UNITED STATES PATENT AND TRADEMARK OFFICE

APPLICATION NO.	FILING DATE	FIRST NAMED INVENTOR	ATTORNEY DOCKET NO.	CONFIRMATION NO.
10/527,789	08/09/2005	Matthias Aikele	4856 / PCT	9555
21553 7590 11/24/2009 FASSE PATENT ATTORNEYS, P.A. P.O. BOX 726 HAMPDEN, ME 04444-0726			EXAMINER ALANKO, ANITA KAREN	
			ART UNIT 1792	PAPER NUMBER
			MAIL DATE 11/24/2009	DELIVERY MODE PAPER

Office Action Summary

DETAILED ACTION

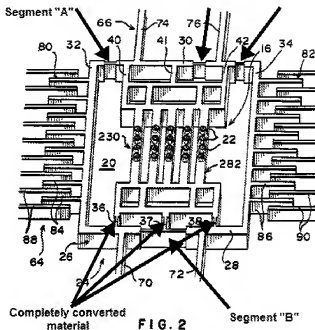
forming of at least two trenches (Fig.4(b), Cross Section B, trenches are inherent since multiple segments are formed within cavity 14; silicon etch, col.9, lines 15-24) spaced apart from each other in the semiconductor substrate with at least one rib 244 positioned between the trenches,

conversion of the substrate material in the area of the trenches (Fig.4c) into an electrically insulating material 246 with complete conversion of the rib 250 arranged between them (col.9, lines 27-42),

forming of a functional structure (e.g., emitters 22 on central stage portion 16, col.4, lines 57-63) within the substrate material which is mechanically connected with the substrate material exclusively by means of the converted substrate material which is formed at the trenches (exact location 36, 37, 38 depends on where electrical isolation is desired, marked by arrows in Fig.2).

As to claim 7, Zhang discloses a continuous insulating oxide (marked by arrows in Fig.2) over longer distances (for example, segment "B" and 37, connecting 70 and 72, is longer than the segment "A" connecting 32 and 30) created by a continuous arrangement of trenches and ribs between them (see Fig.2).
